CHANGE ORDER NUMBER: 2

Project # 1607-102

**Pearson Ranch Road Extension
Williamson County Project No. 1607-102**

Change Order No. 2

Reason for Change

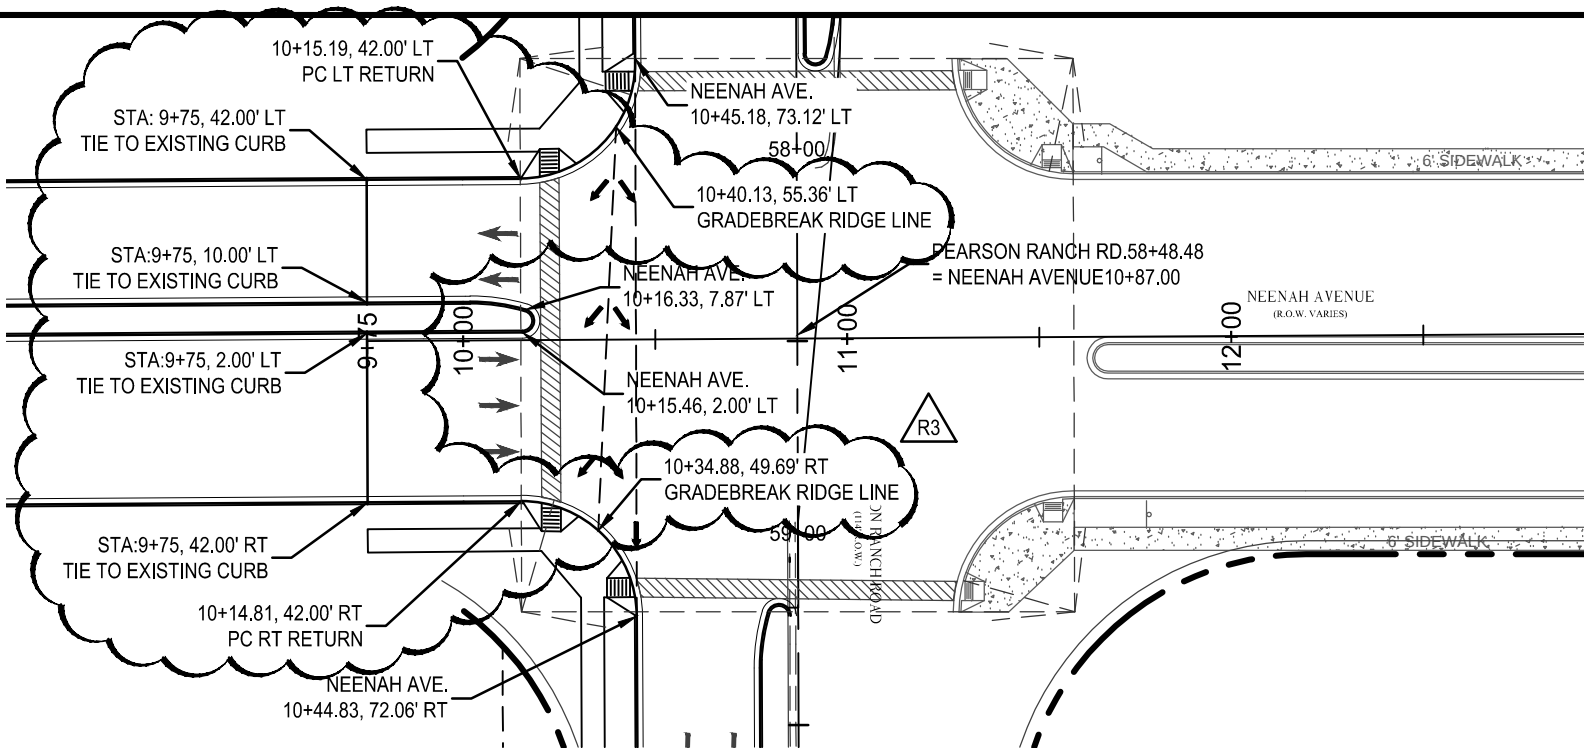
This Change Order provides payment for additional work by the Contractor for intersection tie-in work at Neenah Avenue and Pearson Ranch Road. The tie-in location was adjusted 25' to provide a smooth profile through the intersection. This extended the limits of reconstruction of Neenah west of Pearson Ranch Road. Removal of existing sidewalks, curb & gutter, and rebuilding the pavement section were required to make the grades at the intersection drain properly and for the intersection to ride safely.

NEENAH AVENUE PLAN & PROFILE

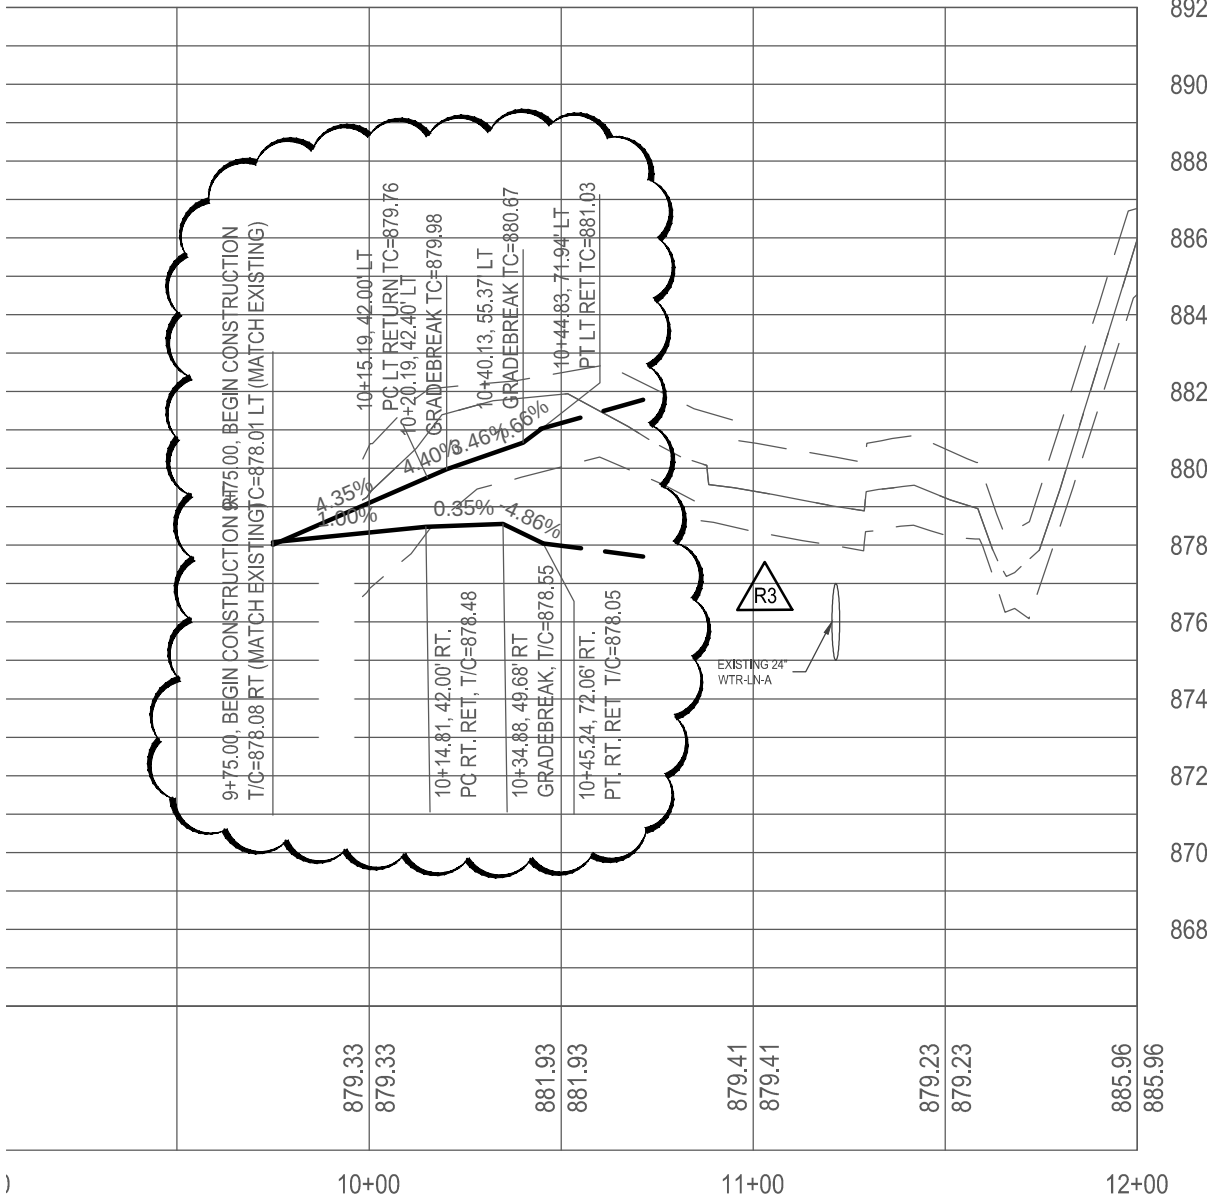
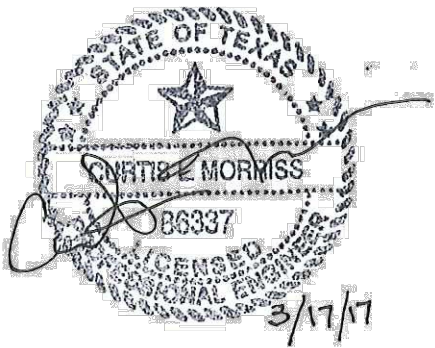
R3	8/17/17	Adjust TOC/SW ELEVS west of int	
R2	2/10/17	Correct curb offsets, adjust TOC in return	
NO.	DATE	REVISION	APPROV.
